Allerton Accessibility Action Plan April 2023

4.1 - ACTION TABLE

Figure 4 — Access around designated off-street parking spaces

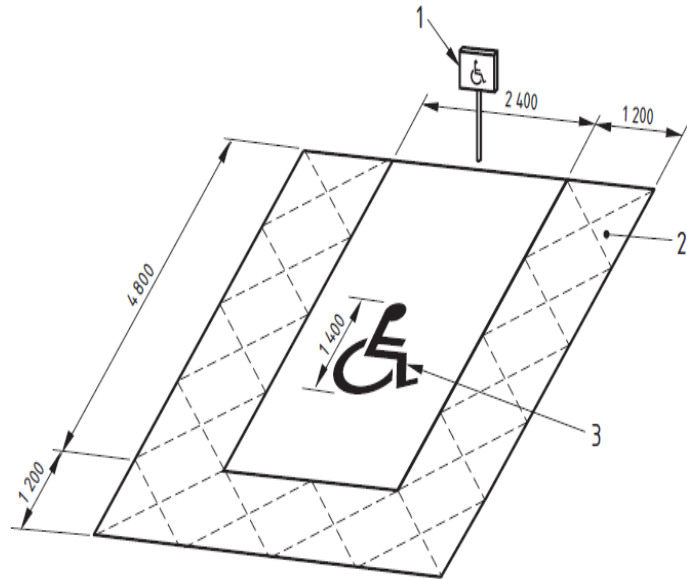
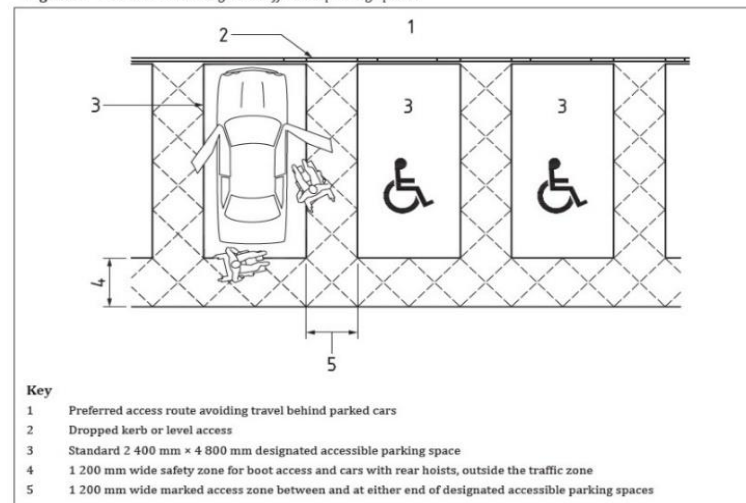
Item Ref.	Details / Issue	Recommendation	Est Cost	Action Taken
PRIORITY A				
2.3	<p>Accessible bays are not of an appropriate size and do not have any recommended markings.</p> <p>The designated accessible parking should be clearly marked out at least 2.4m wide x 4.8m long plus a 1.2m side transfer zone at the side and end of the bay.</p>	<p>The accessible bay markings should provide clearly defined 1200mm transfer zones to both sides and rear and with the required access symbol.</p> <p>BS8300 recommends a sign or, if appropriate, signs should be provided at the entrance to each car park and at each change in direction to direct disabled motorists to designated parking spaces. Also, install a sign to the front of each space as shown:</p>	M

13.11

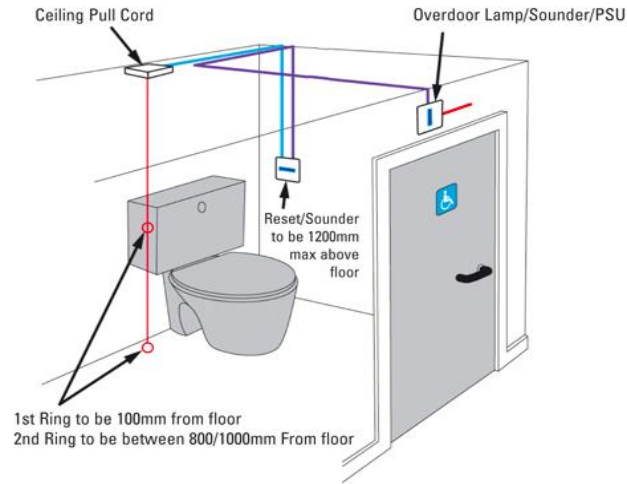
On the day of the survey, the cord alarm within the accessible WCs were not hanging loose hence should someone stumble on the floor they would not be able to reach it.

Alarm is hanging on opposite side to the WC.

Cord alarms should be provided, and monitored to ensure that they function correctly and are located at full length in their correct position so that they can be accessed in the event of an emergency.

Emergency alarm cords should always feature bangles at two heights and stand at 100mm off the ground floor level. According to BS8300 an emergency assistance pull cord should be sited so that it can be operated from the WC and from an adjacent floor area. The emergency assistance pull cord, coloured red, should be provided with two red bangles of 50 mm diameter, one set at a height between 800 mm and 1000 mm and the other set at 100 mm above floor level.

BS8300 recommends that the reset control for the emergency assistance alarm should be clearly marked as such and should be reachable from a wheelchair and, where relevant, from the WC. The reset control should be easy to operate and located with its bottom edge between 800 mm and 1 000 mm above finished floor level. The marking of the reset control should be both visual and tactile.

1.2

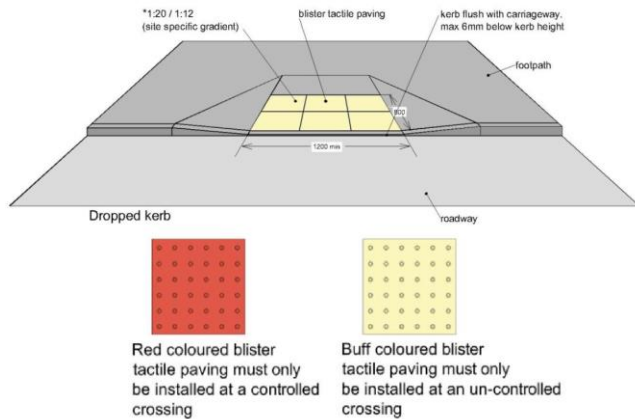
There is no tactile paving provided to some of the possible crossing points on approach to the site to aid people with impaired vision.

There is no crossing point provided from the carpark to the school entrance.

Depending on the responsible authority (i.e. Bradford Council), contact the Highways Department responsible for the routes on approach to the site, and request to provide tactile paving in areas where there are dropped kerbs to aid people with impaired vision. ADM states that an uncontrolled crossing point across the vehicular route should be identified by a buff coloured blister surface.

Any tactile paving a must be installed correctly and in accordance with Guidance on the use of Tactile Paving Surfaces 2021, See:
https://assets.publishing.service.gov.uk/government/uploads/system/uploads/attachment_data/file/1046126/guidance-on-the-use-of-tactile-paving-surfaces.pdf

Diagram 3 Relationship of ramp gradient to the going of a flight

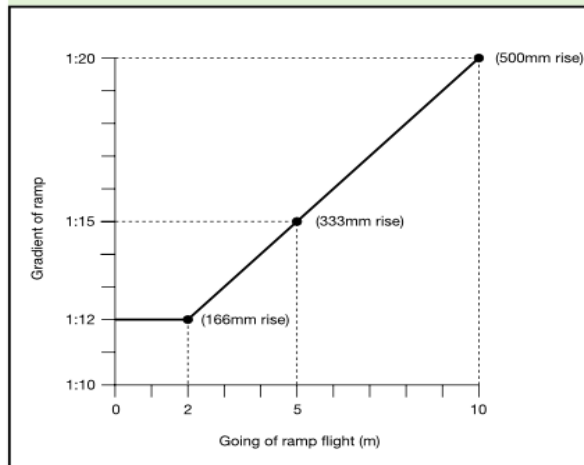
The older ramps seen do not have colour contrast to the surface to indicate the presence of a gradient. Some are also steeper than recommended.

Ramp at Main Entrance - not used as obstructed by flowerpots at top?

Gradient 10 degrees/ 1:5.671

3.1 Entrance area 8
Gradient 1 degree/ 1:57.29

Entrance area 59 gradient shallow

Entrance area 113 gradient 3 degrees/ 1:19.08

Entrance area 56 gradients 5, 7 degrees/ 1:19.08, 1:8.144

Entrance to Nursery area 32 gradient 9 degrees / 1:6.314

ADM require ramp gradients to be within 1:20 - 1:12. Dependent on heritage requirements, surfaces need to be slip-resistant especially when wet and of a colour that contrasts visually with that of the landings.

Some of the current access route ramps are of a gradient steeper than that deemed reasonable under ADM. Where possible, during any future works, the gradients of these primary access routes should be reduced to provide an ADM compliant ramp gradient as below:

3.2

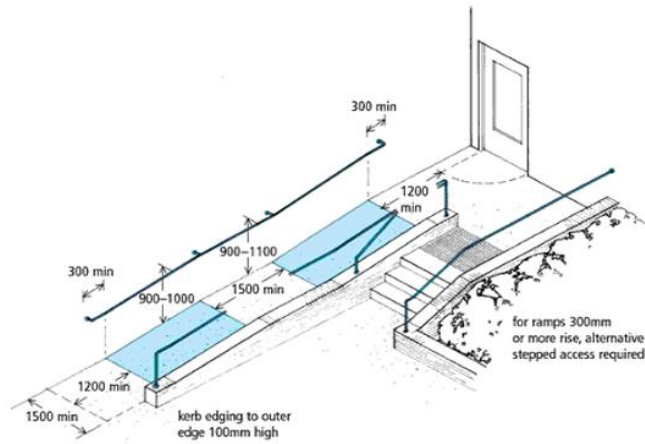
Most ramps had handrails provided on one side.

Some ramps had black handrails which did not contrast where the walls were darker.

Handrails are a relatively simple and cost-effective adjustment that provides a range of benefits; support, guidance, guarding and route definition. All of these features improve accessibility for disabled people. Implement a rolling programme to upgrade handrails to achieve AD M and BS8300 compliance. Ramps serving communal facilities and access routes used by disabled people should be prioritised with others included as part of any refurbishment or alteration works in future.

ADM vol-2 requires handrails on both sides. BS8300 compliant handrails should be installed to both sides of a ramp. The handrails should be coated with nylon or a suitable alternative to ensure that they are not cold to touch. The handrails should provide the required 300mm horizontal landing extensions with the entire handrail located at a height of 900-1000mm from the slope and landing surface as required by BS8300 and ADM vol-2.

4.1

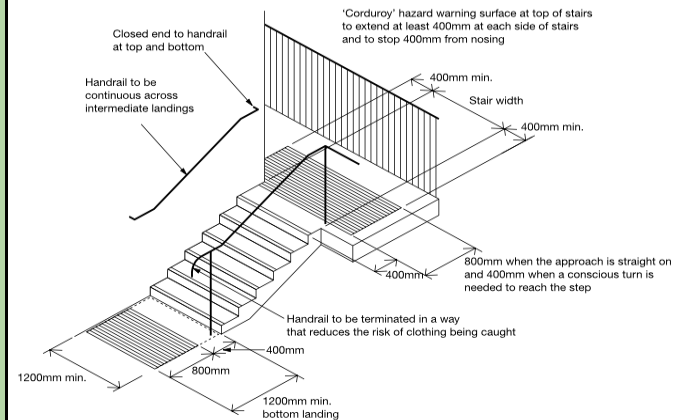
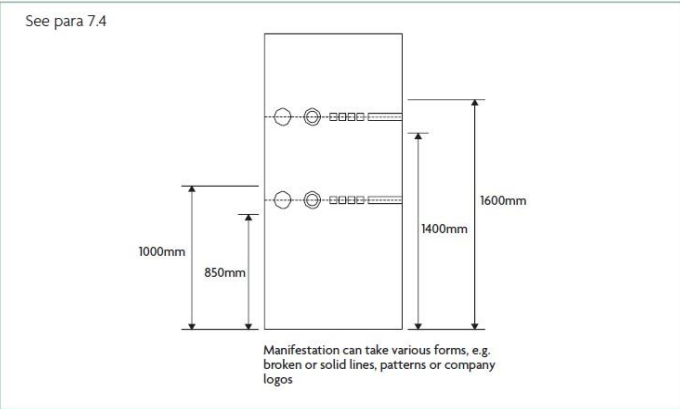
The following external steps do not feature tactile paving to assist people with impaired vision.

Main Entrance Steps

Entrance area 56

MUPA

Tactile paving is an important hazard indicator for blind and partially sighted people and is expected to be present. Implement a rolling programme to install tactile hazard warning paving to the top and bottom of steps where two or more steps are present. Steps serving communal facilities and access routes used by disabled people should be prioritised with others included as part of any refurbishment or alteration works in future. ADM vol-2 requires a corduroy hazard warning surface provided at the top and bottom of each flight of 800mm x 1200mm minimum, 400mm from the step.

BS8300 - To give advance warning of a step, tactile paving with a corduroy hazard warning surface should be provided at the top and bottom of each flight, excluding intermediate landings with continuous handrails. Where the approach to the stair is wider than the flight, the tactile surface should extend beyond the line of each edge of the flight.

15.2

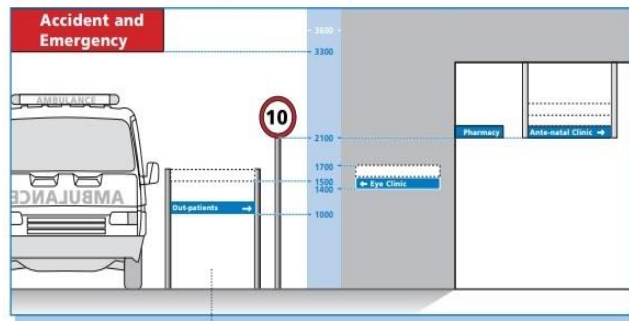
Upon entering the reception area there is a lack of suitable directory signage.

Signs and universally accepted symbols or pictograms, indicating lifting appliances, stairs, toilets, circulation routes and other parts of the building, should be provided in the reception area. The NHS Wayfinding guide and Exhibitions for All (NMS) offers good guidance regarding positioning.

Consistency of sign height and position throughout the premises is important. Signs should be placed between 1400mm and 1700mm for blind and partially sighted people when standing. For wheelchair users signs should be placed between 1000mm and 1100mm above floor level. Signs associated with control panels, e.g. lifts or door entry systems should be located between 900mm x 1200mm, to meet the needs of both wheelchair users and people standing.

The RNIB and the Joint Mobility Unit recommend positioning all signs at eye level (1500 mm), including tactile (embossed) and Braille signs. If posts are used for fixing signs, or signs are free-standing, they must contrast with the environment so they are visible for people with visual impairment.
